# Access Compliance Report Public Rights-of-Way (Pedestrian Signals)

Intersection ID: N/A	Main Street:	Cross Street: N/A	Location: N/A
ADA ID: 991479EBD6CC	Signal Type: One Push Button-Non APS	Overall Compliance: No	Severity Score: BTN 1: N/A BTN 2: N/A No BTN: N/A
Codes/Mitigation Info/Possible Solution		Field Measurements/Component Compliance

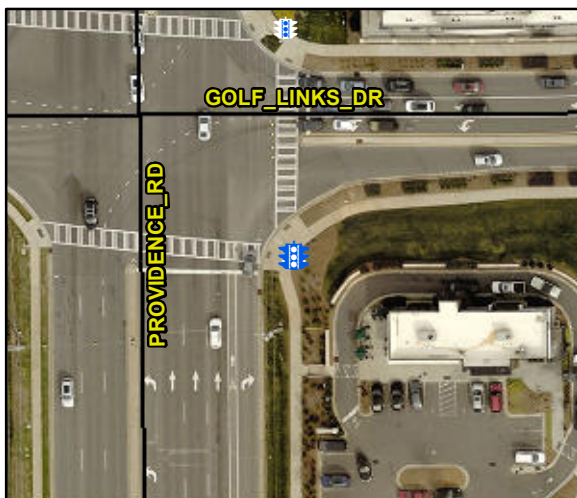
PROW/ADA: TMUTCD 4e.08, R404.2, R404.7.2

N/A	B 1 FWD Approach Width (in)	N/A	N/A	B 2 FWD Approach Width (in)	N/A
N/A	B 1 FWD Approach Obstruction?	Yes	N/A	B 2 FWD Approach Obstruction?	N/A
N/A	B 1 FWD Approach Obstruction Dist (in)	2.0	N/A	B 2 FWD Approach ObstructionDist (in)	N/A
N/A	B 1 PARA Approach?	Yes	N/A	B 2 PARA Approach?	N/A
N/A	B 1 PARA Approach Constrained?	Yes	N/A	B 2 PARA Approach Constrained?	N/A
Yes	B 1 PARA Approach Reach (in)	5.0	N/A	B 2 PARA Approach Reach (in)	N/A
No	B 1 PARA Approach Width (in)	48.0	N/A	B 2 PARA Approach Width (in)	N/A
N/A	B 1 PARA Approach Obstruction?	Yes	N/A	B 2 PARA Approach Obstruction?	N/A
N/A	B 1 PARA Approach Obstruction Dist (in)	2.0	N/A	B 2 PARA Approach ObstructionDist (in)	N/A
Yes	B 1 Clear Floor Space Slope (%)	0.6	N/A	B 2 Clear Floor Space Slope (%)	N/A
No	B 1 Clear Floor Space XSlope (%)	4.3	N/A	B 2 Clear Floor Space XSlope (%)	N/A
N/A	B 1 PAR Slope (%)	N/A	N/A	B 2 PAR Slope (%)	N/A
Yes	B 1 Height (in)	41.0	N/A	B 2 Height (in)	N/A

N/A	B 1 Clear Xing Direction?	Yes	N/A	B 2 Clear Xing Direction?	N/A
	B 1 Crossing Direction	To W		B 2 Crossing Direction	N/A
Yes	B 1 DistanceTo XWalk (in)	0.0	N/A	B 2 DistanceTo XWalk (in)	N/A
No	B 1 DistanceTo Curb (in)	78.0	N/A	B 2 DistanceTo Curb (in)	N/A
Yes	B 1 Diameter (in)	2.0	N/A	B 2 Diameter (in)	N/A

Possible Solutions: Replace Signal Push Button With APS Button on New Post. Remove & Relocate Sign.
